BRUNSWICK STEAM ELECTRIC PLANT, UNIT NOS. 1 AND 2
DOCKET NOS. 50-325 AND 50-324/LICENSE NOS. DPR-71 AND DPR-62
REQUEST FOR LICENSE AMENDMENTS TO
REVISE TECHNICAL SPECIFICATION
PRESSURE-TEMPERATURE LIMIT CURVES

Basis For Change Request

CP&L Calculation 0B11-0005, Revision 1
"Development of RPV Pressure-Temperature Curves
For BNP Units 1 & 2
For Up To 32 EFPY of Plant Operation"

Figure A-1. Curve A (BSEP-1, 32 EFPY)

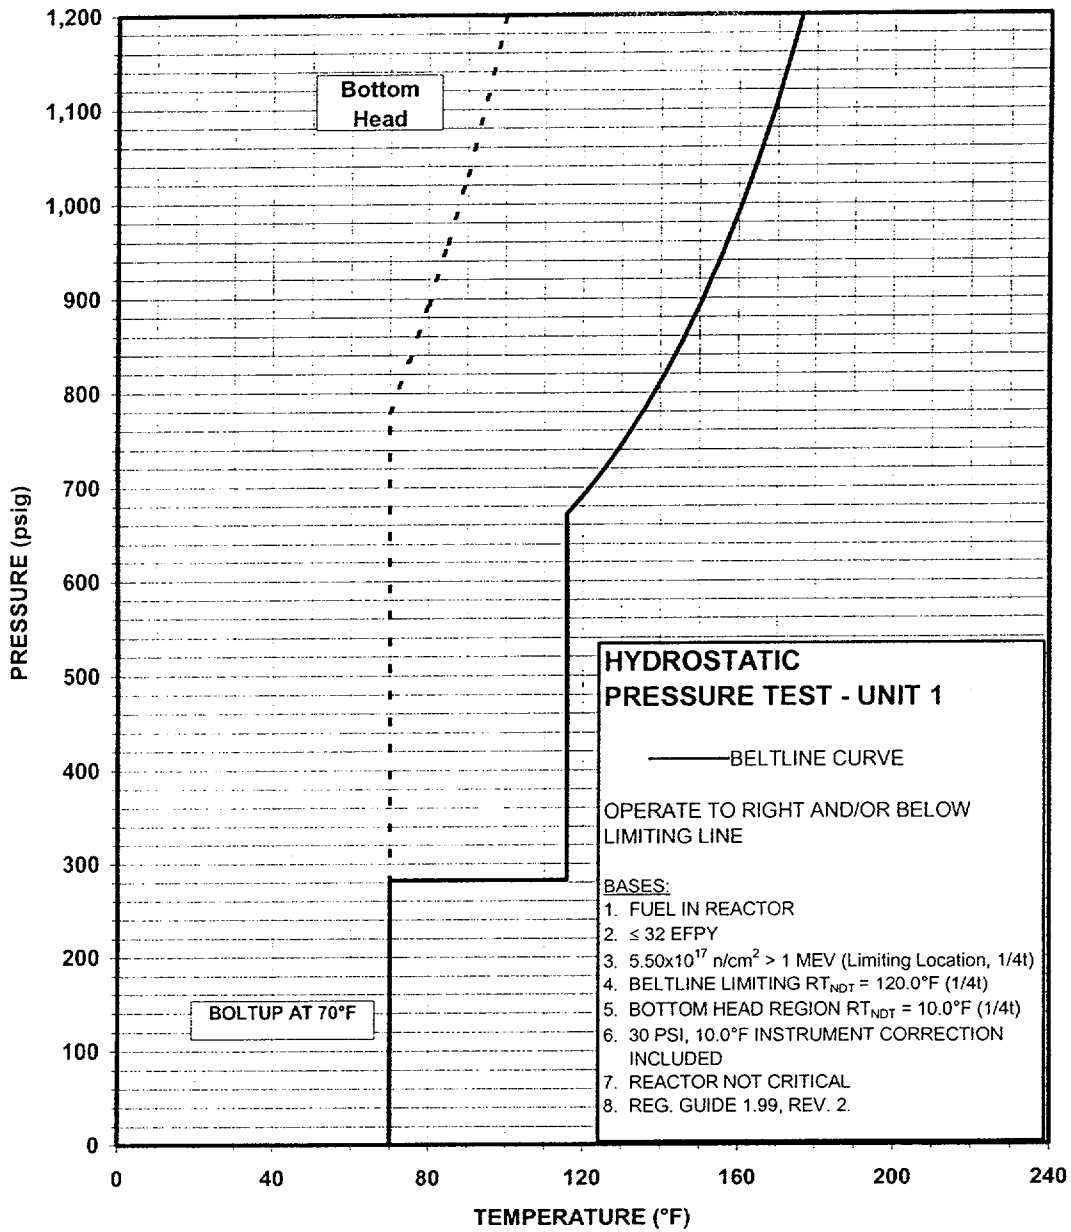
Figure 3.4.9-1 is being revised to provide RCS P-T limits applicable to normal operation with the core not critical that are valid up to 32 EFPY. Figure 3.4.9-2 is being revised to provide RCS P-T limits applicable to normal operation with the core critical that are valid up to 32 EFPY. In order to provide future flexibility in performing hydrostatic and leak tests, three separate P-T limits curves applicable to hydrostatic and leak tests are being proposed. Figure 3.4.9-3 is being revised to provide P-T limits applicable to hydrostatic and leak tests that are valid up to 20 EFPY. New Figures 3.4.9-4 and 3.4.9-5 are being added to provide P-T limits applicable to hydrostatic and leak tests that are valid up to 24 EFPY and 32 EFPY, respectively. To support the addition of Figures 3.4.9-4 and 3.4.9-5, Surveillance Requirement 3.4.9.2.a is being revised to require completion of the following action within 30 minutes:

The revised P-T limits curves provide limitations valid until 32 EFPY. Each TS P-T limit figure contains two curves, a beltline curve and a bottom head curve. The beltline curve is based on the N16A/B nozzles; the N16A/B nozzles are the limiting reactor pressure vessel (RPV) material and are located in the beltline region. The bottom head curves define the P-T limits for the bottom head region of the RPV.

Figure x.x.x-x (page 1 of 1)
RCS Pressure and Temperature Limits
Hydrostatic and Leak Tests ≤ 32 EFPY
